## *City of El Paso – City Plan Commission Staff Report*

**Case No:** SULD12-00001 Tierra Del Este Phase V  
**Application Type:** Land Study  
**CPC Hearing Date:** March 7, 2013  
**Staff Planner:** Nathaniel Baker, (915) 541-4192, [bakernt@elpasotexas.gov](mailto:bakernt@elpasotexas.gov)  
**Location:** East of John Hayes and South of Pebble Hills  
**Acreage:** 611.4 acres (0.96 of a square mile)  
**Rep District:** ETJ (adjacent to District 5)  
**Existing Use:** Vacant  
**Existing Zoning:** ETJ  
**Proposed Zoning:** ETJ  
**Nearest Park:** Linear Park on Mike Price Drive  
**Nearest School:** Adjacent School on the SW corner of John Hayes and Pebble Hills  
**Park Fees Required:** N/A  
**Impact Fee Area:** Eastside Impact Fee Service Area  
**Property Owner:** Ranchos Real Land Holdings, LLC  
**Applicant:** Conde Ltd  
**Representative:** Conde Inc.

# ATTACHMENT 3

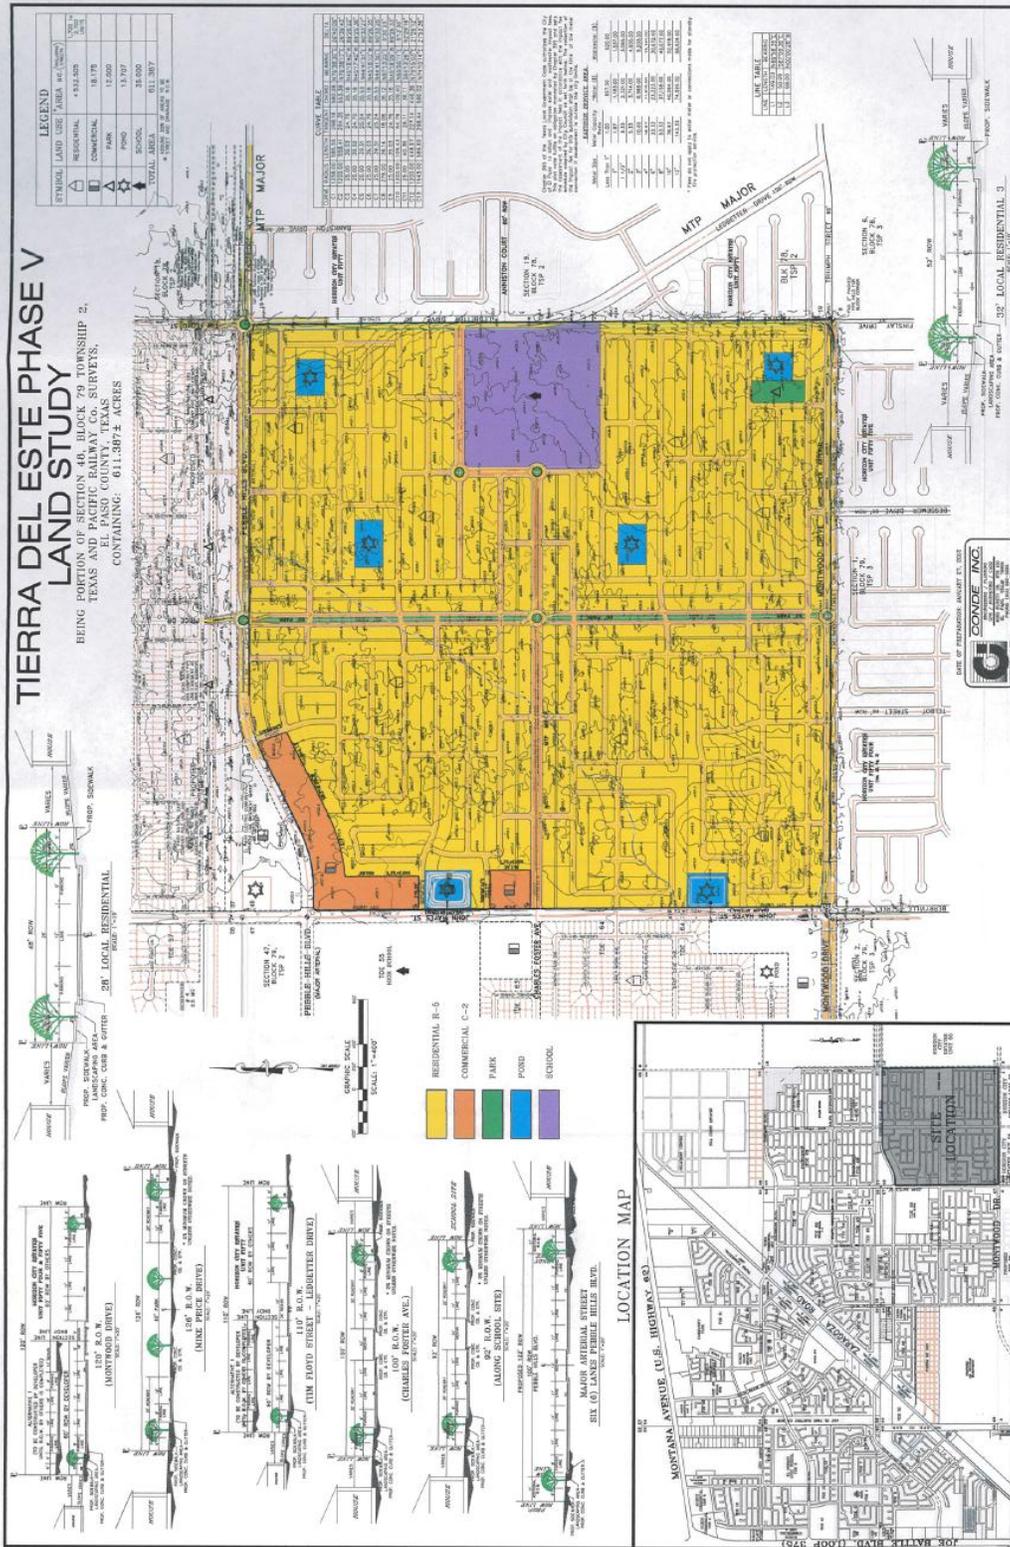
Block perimeter lengths shall not exceed 2400 feet in length per the current code.

1. Parks Department recommends a median "Linear park" be provided along Charles Foster Ave., same as the one along Mike Price Dr.
2. Parks Department recommends for centrally located parks (minimum of one acre) be provided with-in the northeast, northwest and southwest quadrants.

3. Verify total park acreage (12.00) as noted on "Legend" – Per scale dimensions of proposed park sites, only 9.4 acres of parkland were able to be accounted for.

4. Applicant needs to provide covenants restricting the use to a Single-family dwelling unit per lot since subdivisions within the ETJ do not have a district designation.

5. Applicant needs to provide covenants restricting the use to general commercial only for all commercial areas ( $\pm$  18.17 acres) since subdivisions within the ETJ do not have a district designation.
